**PROCUREMENT OF TWO (2) UNITS OF APPROX. 94-METER MULTI-ROLE RESPONSE VESSEL (APPROX. 94M MRRV)  
 BID CLARIFICATIONS AND AMENDMENTS  
 Bid Bulletin No. 1**

**B. CLARIFICATIONS**

## LIST OF HELICOPTER

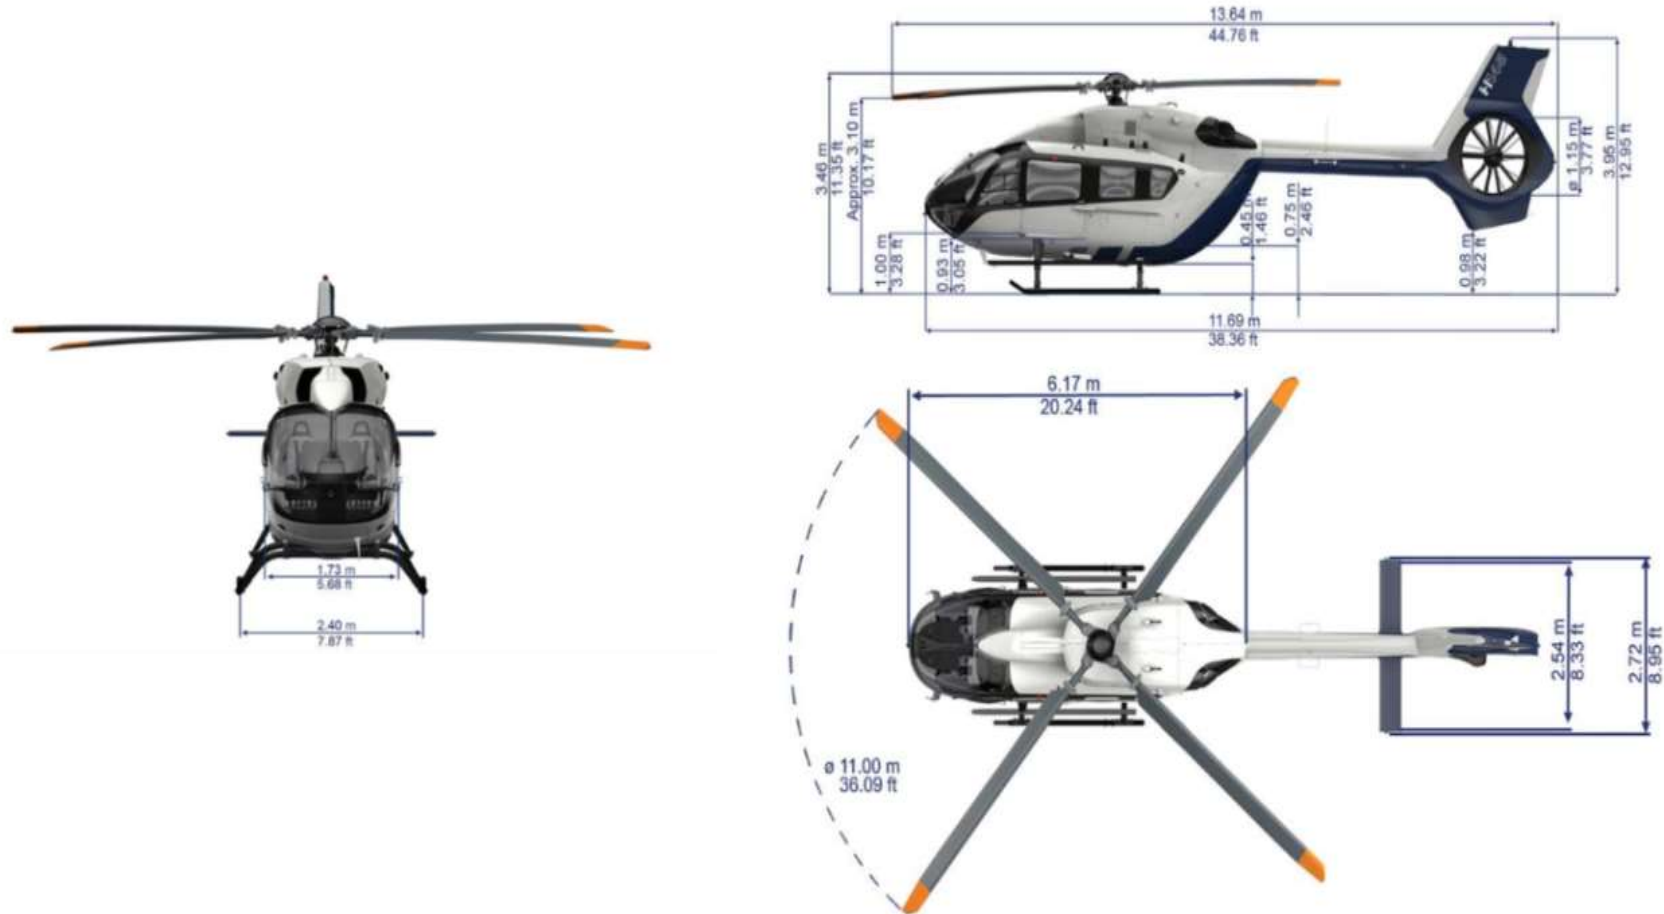
No.	Item	Page	Technical Specification	Bidder's Queries	Answer												
	Launching Facilities			specification for it.													
49	16. Helicopter Hanger, Control Room, Helideck and Helicopter Launching Facilities	H-18	1) Helicopter Hanger Fixed helicopter hanger shall be provided. Helicopter hanger shall be designed as to safely store and lash the one EC145 Eurocopter through manual operations, with applicable safety regulations.	Please let us know the specification of EC145 - Principal particulars (size, weight) - Is the blade foldable? (if not, it is impossible to store EC145 in hanger)	Blade of EC145 is foldable. <b>DIMENSIONS</b> <table border="1"> <tr> <td>Length</td> <td>13.64 m</td> </tr> <tr> <td>Height</td> <td>3.95 m</td> </tr> <tr> <td>Main rotor diameter</td> <td>11.0 m</td> </tr> </table> <b>MAIN CHARACTERISTICS</b> <table border="1"> <tr> <td>MTOW (within the AGW flight envelope up to 3,800 kg)</td> <td>3,700 kg</td> </tr> <tr> <td>Useful load</td> <td>1,781 kg</td> </tr> <tr> <td>Sling capacity</td> <td>1,600 kg</td> </tr> </table> Please refer to the attached EC 145 Specifications.	Length	13.64 m	Height	3.95 m	Main rotor diameter	11.0 m	MTOW (within the AGW flight envelope up to 3,800 kg)	3,700 kg	Useful load	1,781 kg	Sling capacity	1,600 kg

Length	13.64 m																
Height	3.95 m																
Main rotor diameter	11.0 m																
MTOW (within the AGW flight envelope up to 3,800 kg)	3,700 kg																
Useful load	1,781 kg																
Sling capacity	1,600 kg																
50	16. Helicopter Hanger, Control Room, Helideck and Helicopter Launching Facilities	H-18	1) Helicopter Hanger Slipping preventing net, rubber mat	With regard to the Slipping Preventing Net, we understand the "Net" is mentioned as nonslip paint for helicopter landing deck. Is it correct? If not, please let us know the detail. Also, please let us know the purpose of rubber mat in hanger.	Yes, it refers to nonslip paint for helicopter landing deck and hangar which the shipbuilder/ contractor shall provide. This is in addition to helideck guardrails with nets. Rubber Matt shall be used to soak up drips, spills, splatters, and clean-up oil based spills.
